Number	Description
1	Revised or Added Plan Sheet Nos. 1-2, 7-9, 12; Amendment EBS Download Required.

MISSISSIPPI DEPARTMENT OF TRANSPORTATION
DISTRICT 3 MATERIALS LAB HVAC AND
LIGHTING REPLACEMENT
DETAILED INDEX

Project Number: BWO-3074-82(004)

1 HVAC FLOOR PLAN - DUCTWORK

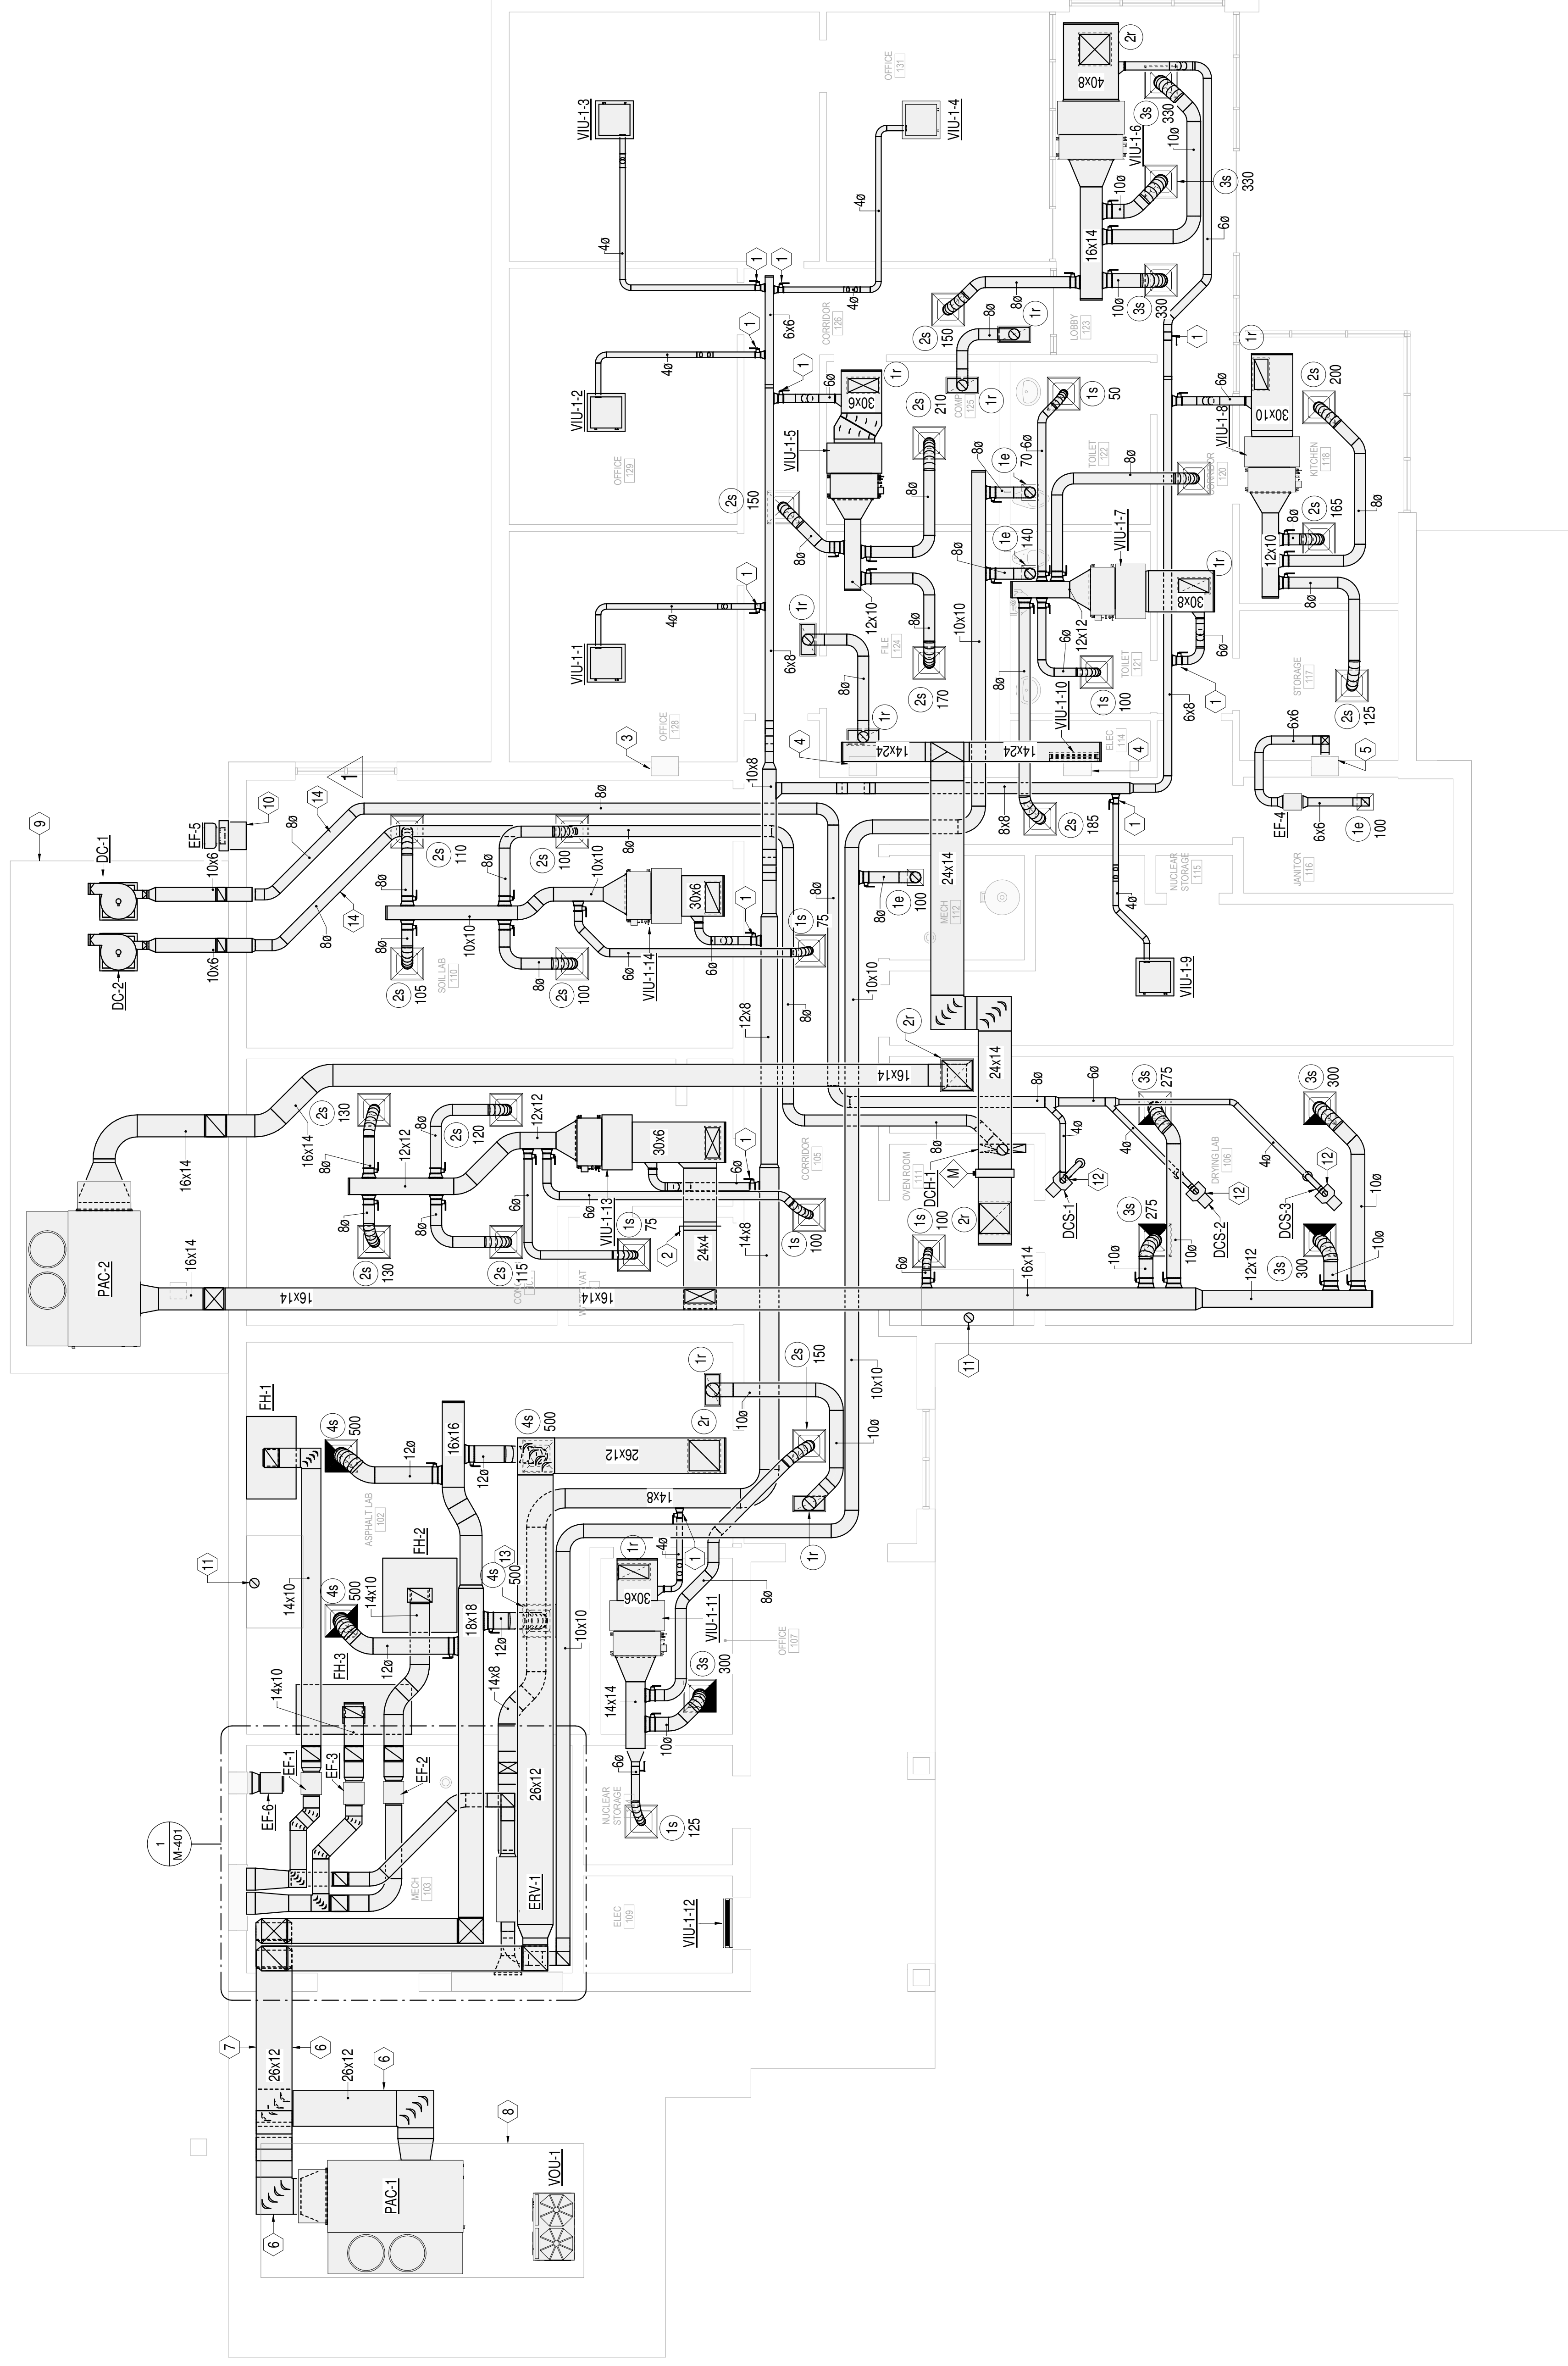
MISSISSIPPI DEPARTMENT OF TRANSPORTATION DISTRICT 3 MATERIALS LAB HVAC AND LIGHTING REPLACEMENT HVAC FLOOR PLAN - DUCTWORK		Project Number: BWO-3074-82(004) COUNTY: YAZOO	WORKING NUMBER M-101	SHEET NUMBER 12
FILENAME: BWO-3074-82(004)-M-101.dgn	DESIGN TEAM: CDFL			
11/5/17	CHANGE NOTE 11, ADD NOTE 14			
	REVISION			
	BY

- 11. CONNECT TO EXISTING OVEN EXHAUST PORT WITH 70 DUCT. DUCT TO BE DOUBLE-WALLED EQUAL TO SELKIRK DSP. PROVIDE WALL THIMBLE EQUAL TO SELKIRK WTT FOR PENETRATIONS THROUGH COMBUSTIBLE MATERIALS. ROUTE UP THROUGH ROOF AND TERMINATE WITH ROOF CAP. SEE DETAIL.

- 13. BLANK OFF SIDE OF DIFFUSER THROWING TOWARDS FUME HOOD.
- 14. DUST COLLECTOR DUCT TO BE ROUND, WELDED LONGITUDINAL SEAM TYPE. ALTERNATIVELY, CLAMPING-TYPE EQUAL TO NORDFAB OF MAY BE USED.
